Subject: 2009 Annual Radioactive Effluent Release Report

LASALLE COUNTY NUCLEAR POWER STATION
EFFLUENT AND WASTE DISPOSAL ANNUAL REPORT (2009)
SUPPLEMENTAL INFORMATION

ODCM Change Summary Matrix

**SIMPLIFIED GASEOUS RADWASTE AND
 GASEOUS EFFLUENT FLOW DIAGRAM
 (SHEET 1 OF 2)**

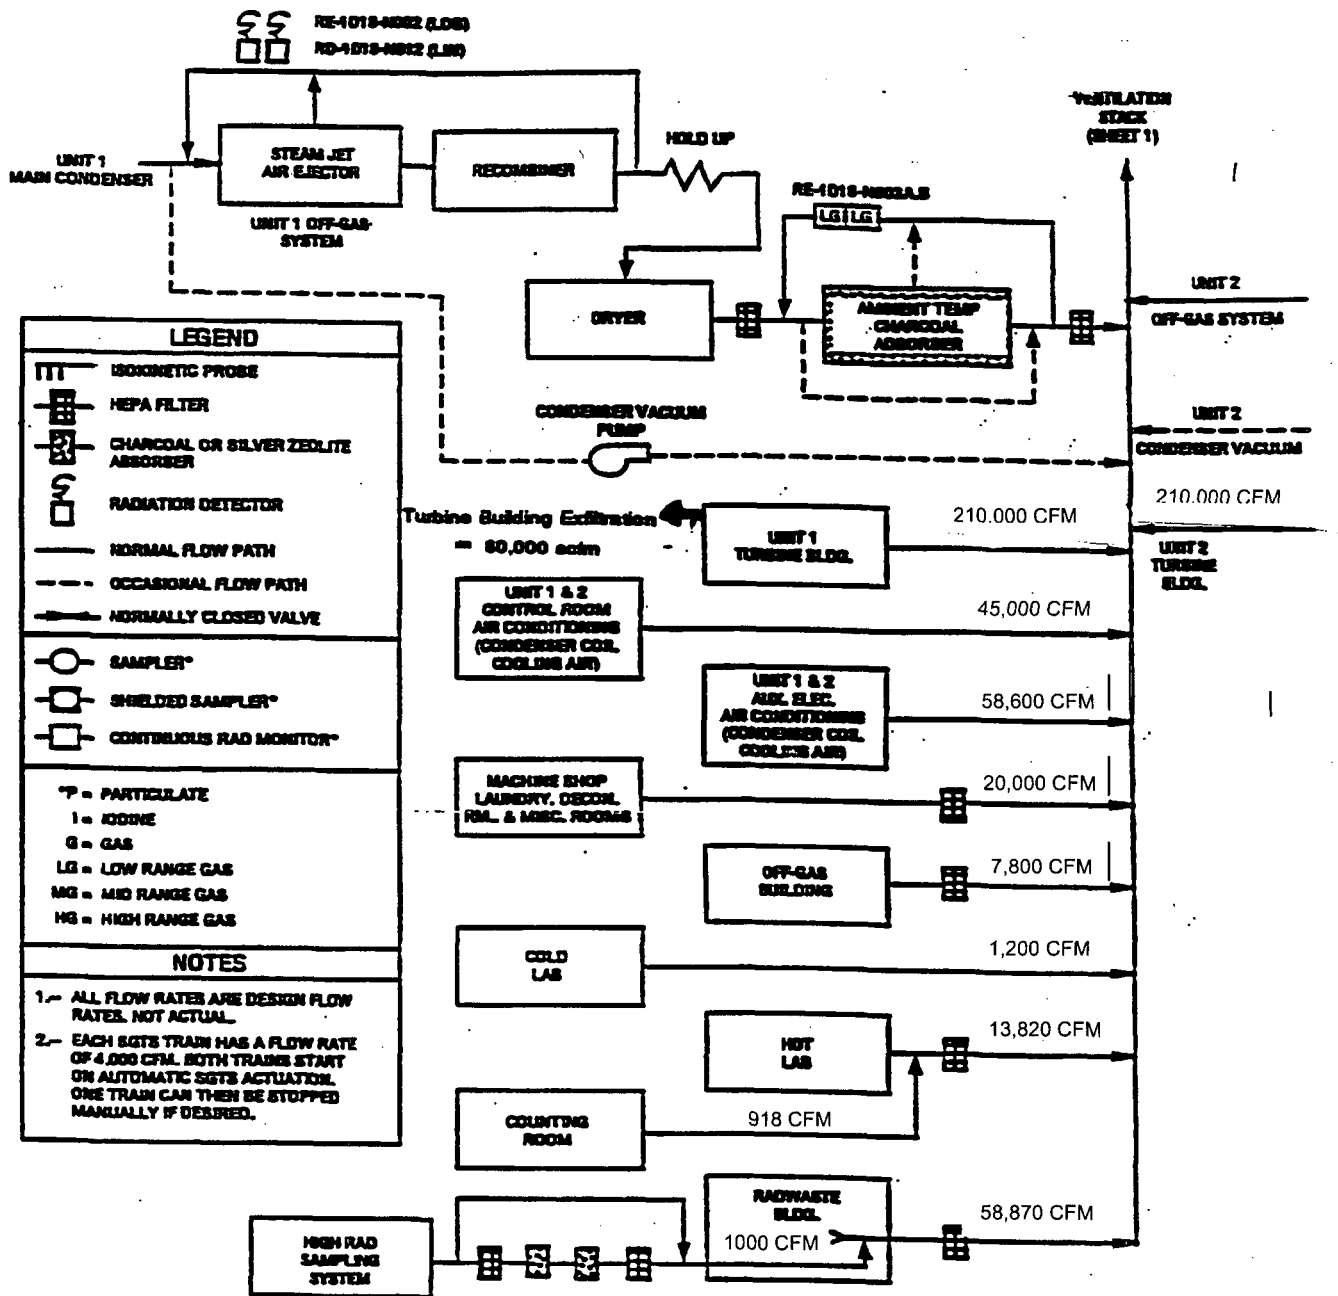
1	II.6-12	II.6-11	EG	Biros Dairy added to figure 6-3
2	II.2-14	II.2-14	EG	0PLD1J was mislabeled as 0PLD4J in Figure 2-1, sheet 1 of 2. Figure 2-1, sheet 1 of 2 has been updated to correctly display 0PLD1J.
3	II.2-14	II.2-14	EG	EPN 0PLD2J was not correctly labeled in Figure 2-1, sheet 1 of 2. Figure 2-1, sheet 1 of 2 has been updated to include the 0PLD2J EPN.
4	II.2-14	II.2-14	EG	EPN 0PLD5J was not correctly labeled in Figure 2-1, sheet 1 of 2. Figure 2-1, sheet 1 of 2 has been updated to include the 0PLD5J EPN.
5	II.2-15	II.2-15	EG	Flows for the Unit 1 & 2 Auxiliary Electric Rooms, in CFM, were not labeled on Figure 2-1, sheet 2 of 2. Figure 2-1, sheet 2 of 2 has been updated to include the Unit 1 & 2 Auxiliary Electric Rooms flows.
6	II.2-15	II.2-15	EG	Flows for the Machine Shop Laundry Decon Room and Miscellaneous Rooms, in CFM, were not labeled on Figure 2-1, sheet 2 of 2. Figure 2-1, sheet 2 of 2 has been updated to include the Machine Shop Laundry Decon Room and Miscellaneous Rooms flows.

FIGURE 2-1
**SIMPLIFIED GASEOUS RADWASTE AND
 GASEOUS EFFLUENT FLOW DIAGRAM
 (SHEET 2 OF 2)**

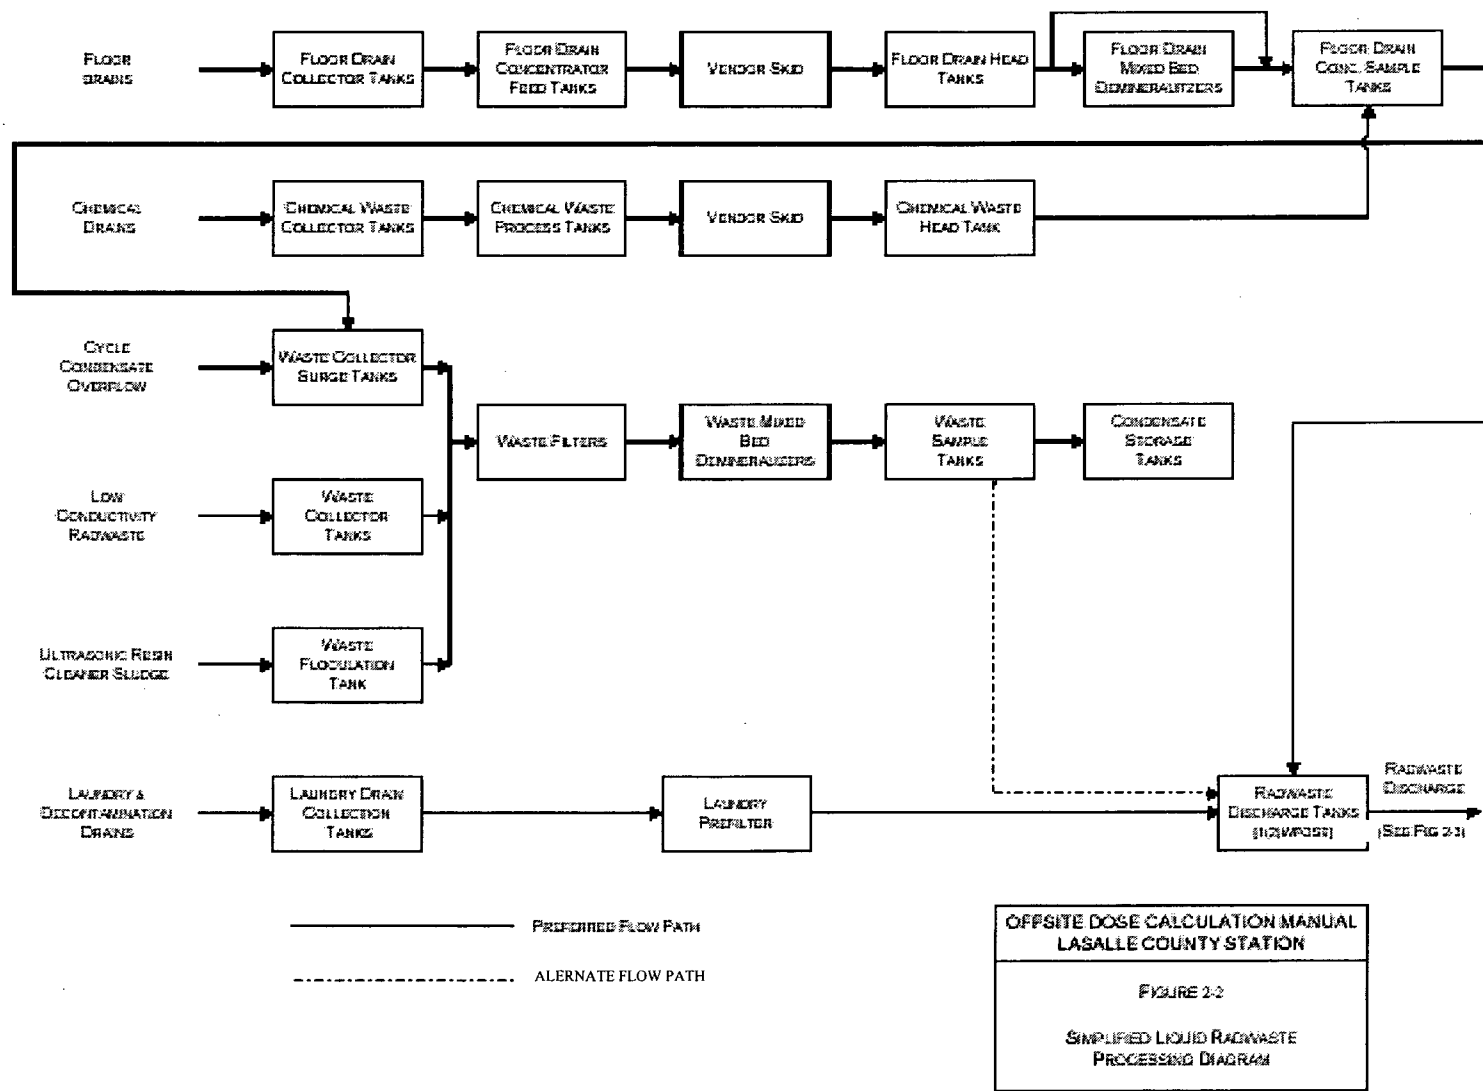
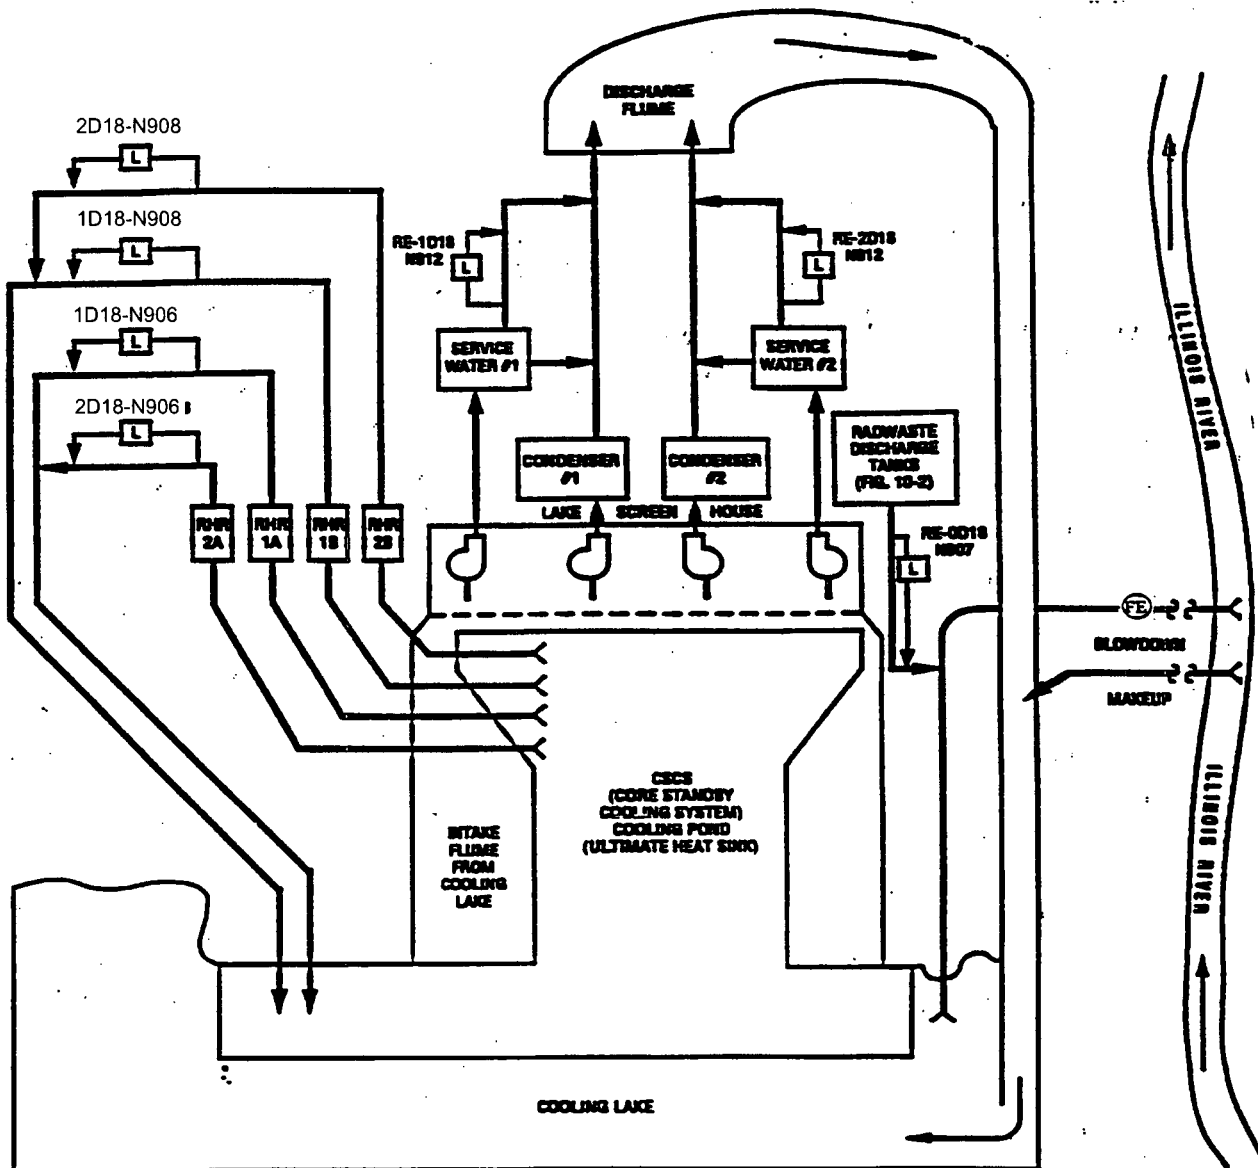
7	II.2-15	II.2-15	EG	Flows for the Off-gas Building, in CFM, were not labeled on Figure 2-1, sheet 2 of 2. Figure 2-1, sheet 2 of 2 has been updated to include the Off-gas Building flows.
8	II.2-17	II.2-17	EG	EPN label for 1D18-N906 was not legible in Figure2-3. Figure 2-3 has been updated to improve the 1D18-N906 label.
9	II.2-17	II.2-17	EG	EPN label for 2D18-N906 was not legible in Figure2-3. Figure 2-3 has been updated to improve the 2D18-N906 label.
10	II.2-17	II.2-17	EG	EPN label for 1D18-N908 was not legible in Figure2-3. Figure 2-3 has been updated to improve the 1D18-N908 label.
11	II.2-17	II.2-17	EG	EPN label for 2D18-N908 was not legible in Figure2-3. Figure 2-3 has been updated to improve the 2D18-N908 label.
12	1 – 9	1 – 9	EG	The Table Of Contents, pages 1 – 9 needed alignment of the listed page numbers with the actual page numbers of the body of the ODCM. The Table Of Contents has been revised to align with the body of the ODCM.
